**TOWN OF HERNDON, VIRGINIA
ARCHITECTURAL REVIEW BOARD WORK SESSION AGENDA
JULY 06, 2022
HERNDON MUNICIPAL CENTER
LARGE CONFERENCE ROOM, 2nd Floor
777 LYNN STREET
7:30 P.M.**

Title: ARB #22-013; New signage; 625 Elden Street

Subject: Pre-application ARB Discussion Item, DP #21-01, 555 Herndon Parkway

North Elevation

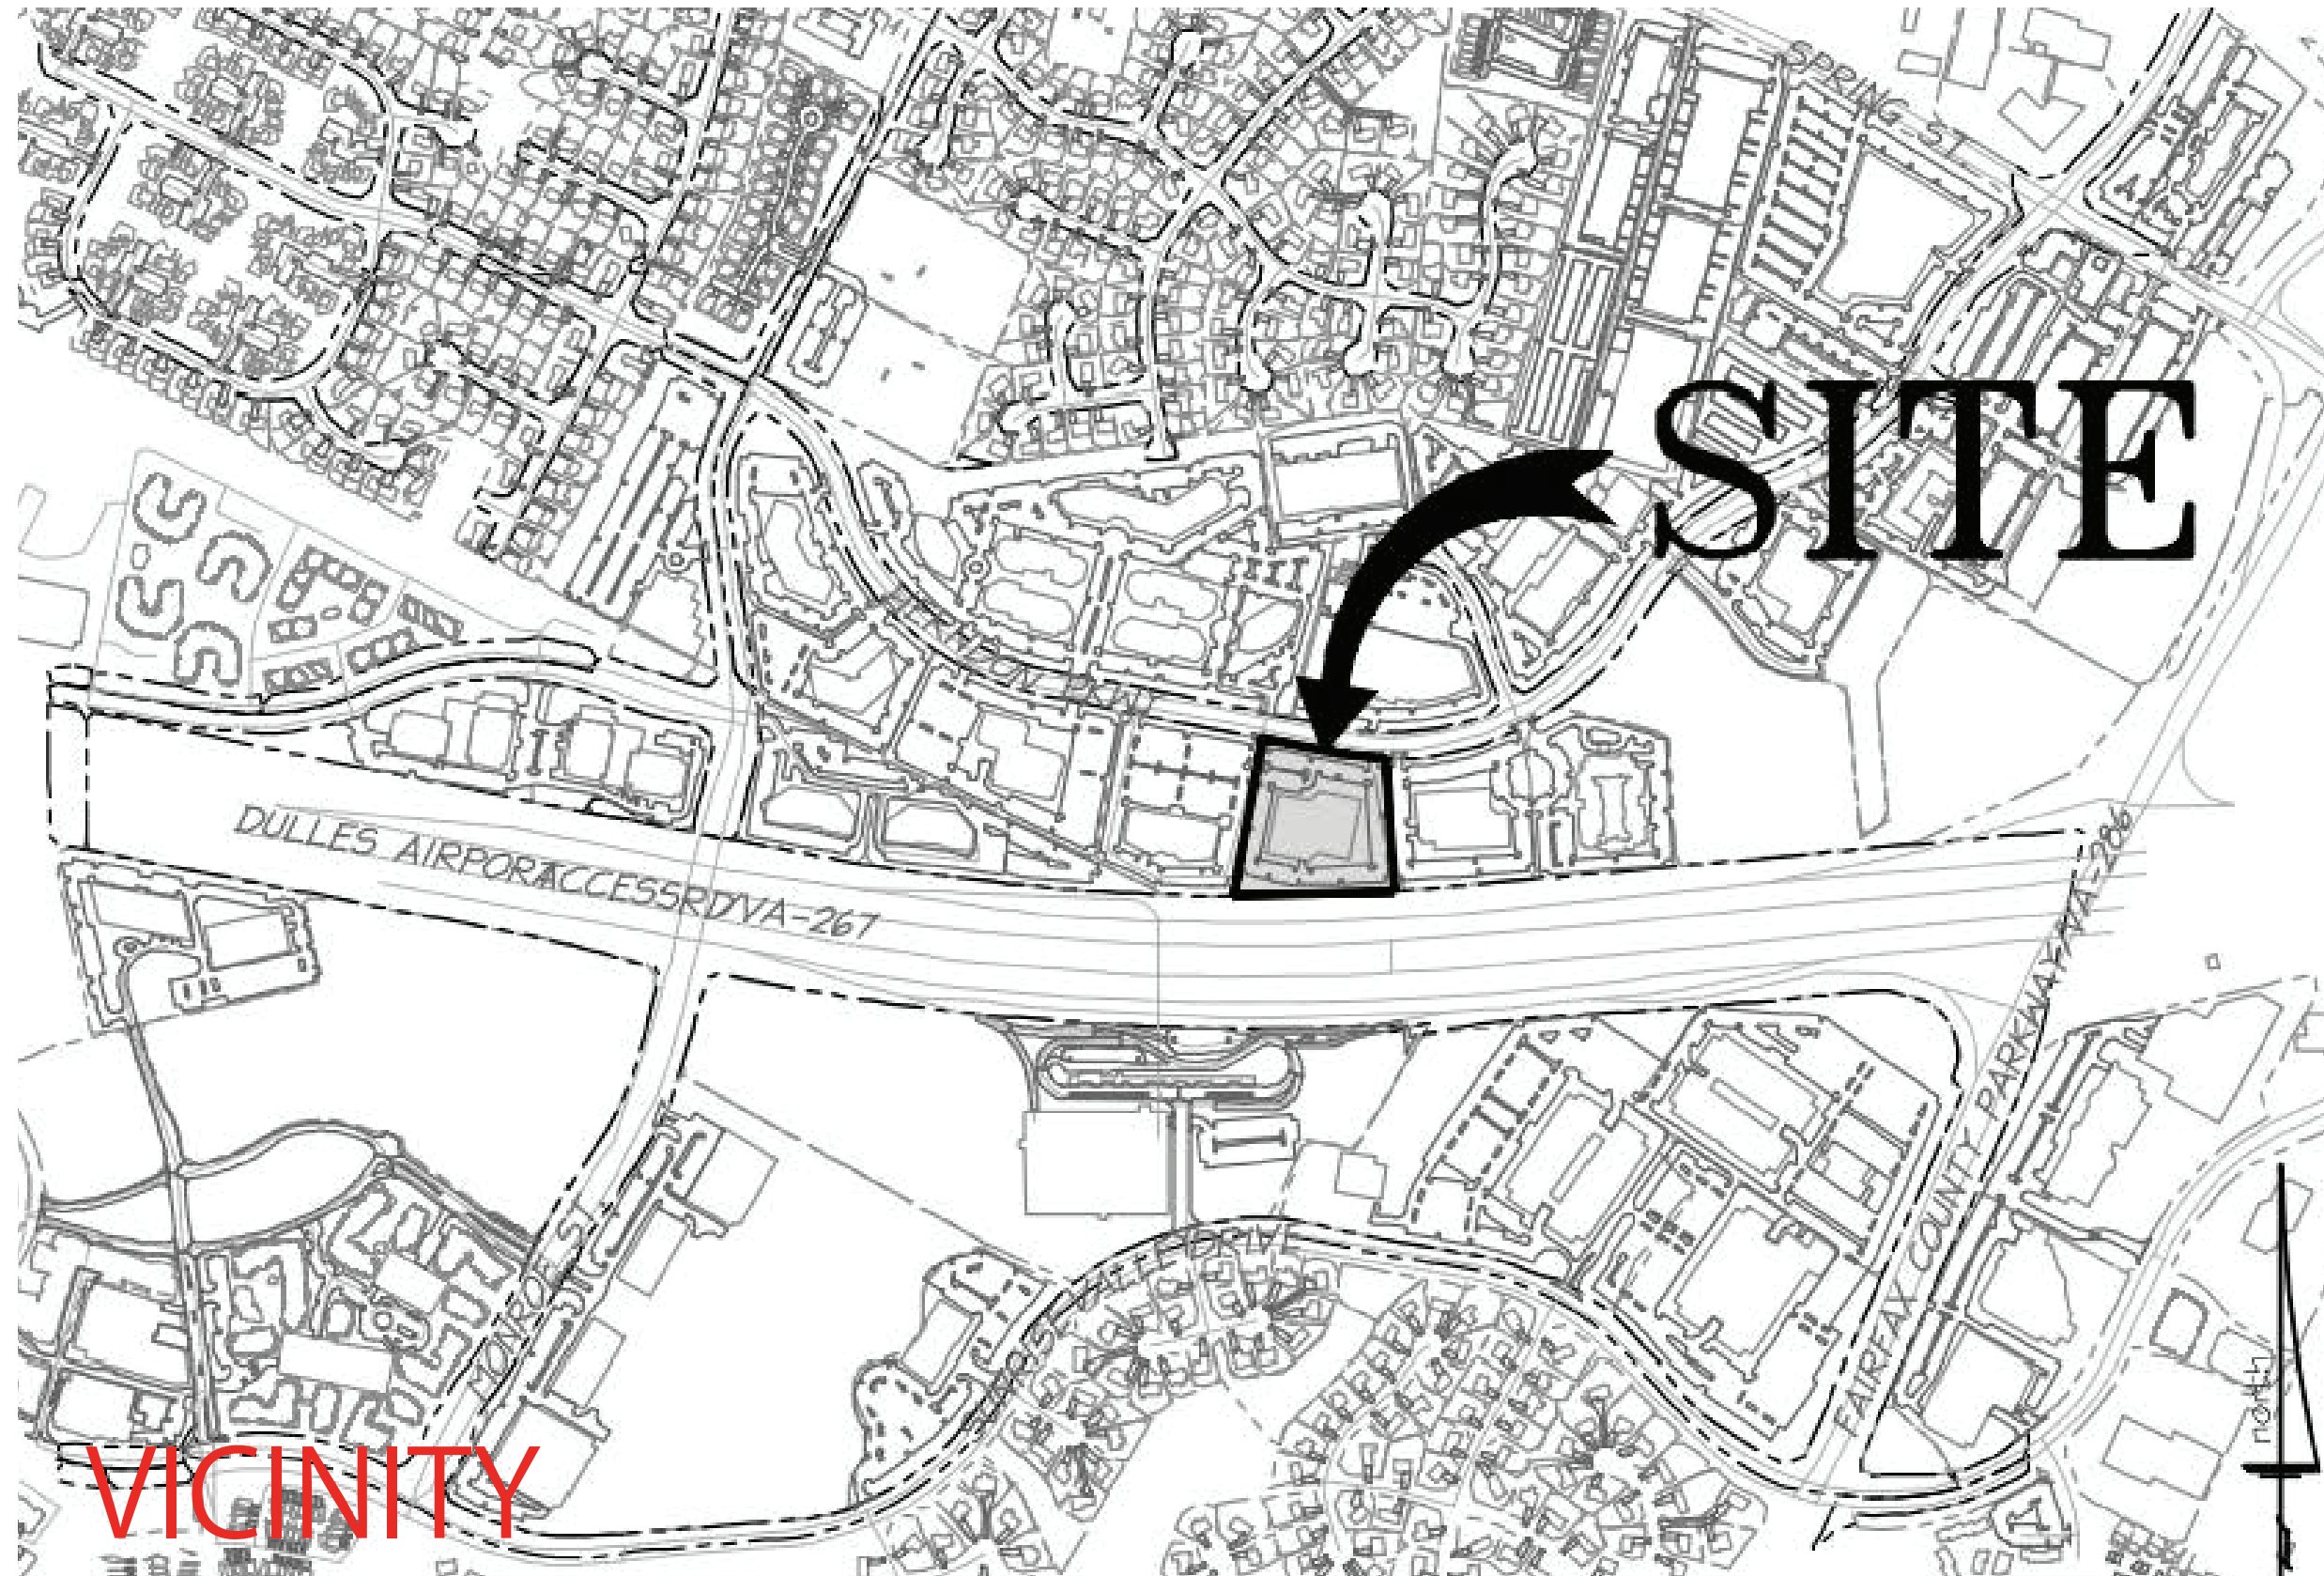
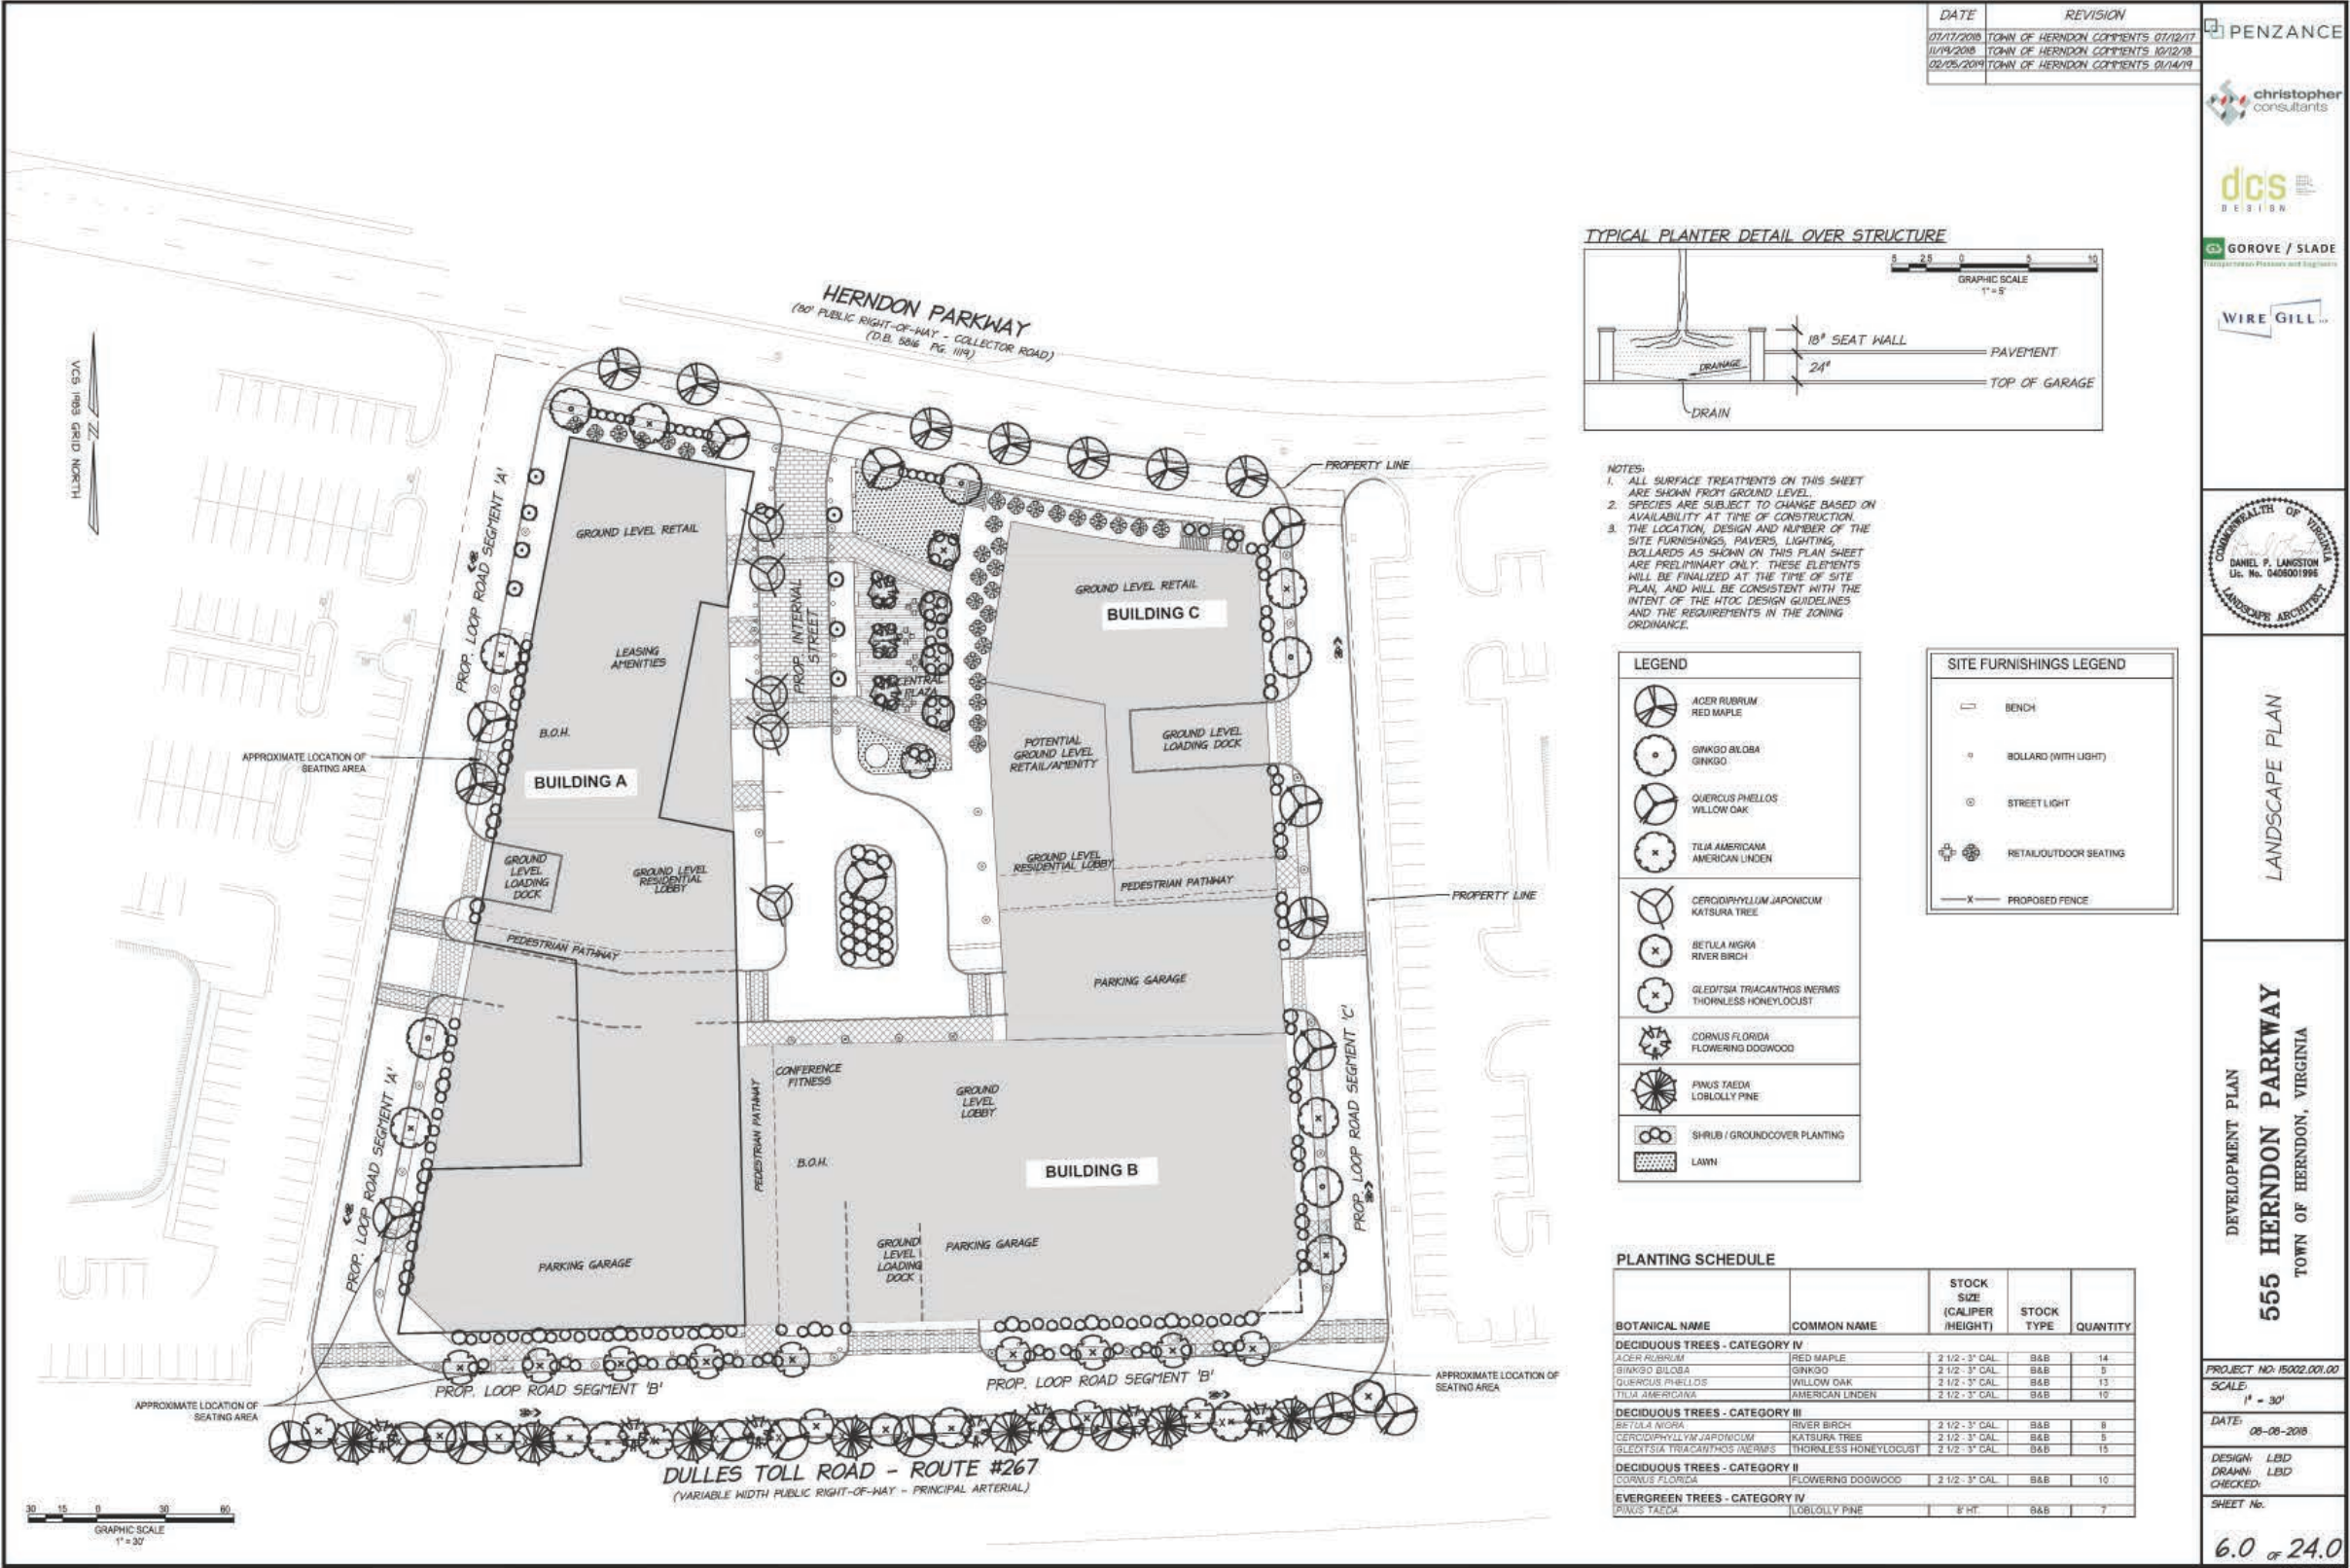
Section C of the Urban Design and Architectural Guidelines emphasizes the need for towers to have an articulated base, middle and top. As proposed, this tower does not meet that guideline. The garage access on the ground floor could be considered a base, however, it is not clearly articulated. It is difficult to review completely for the aesthetics of this portion of the design because there are limitations in the size and detail of the renderings provided. One way this is evident is that the renderings do not show how the metal mesh screening the garage portion of the tower interacts with the glazing above it. The board may wish to discuss this with the applicant. There may be a way to address the articulation of a base, middle, and top of the building using the divisions of parking and interior spaces that exist in the building already.

Staff believes that the overall design of the residential facades could be modified to more closely adhere to the guidelines by using more variation in the façade treatment. The variation that exists as proposed is minimal and color and material changes are not organized in a visually satisfactory manor but give the impression of arbitrary differentiation between areas of the façade. The Urban Design and Architectural Guidelines specify that midrise developments should be articulated to resemble an ensemble of smaller buildings. This indicates a level of order that the current design does not display. Variation in materials as proposed is important but the variation could be enhanced with a more varied color scheme and organized system of architectural divisions. Staff believes that the articulation of a cap or finish on the roofline of the residential portions may also provide needed additional articulation.
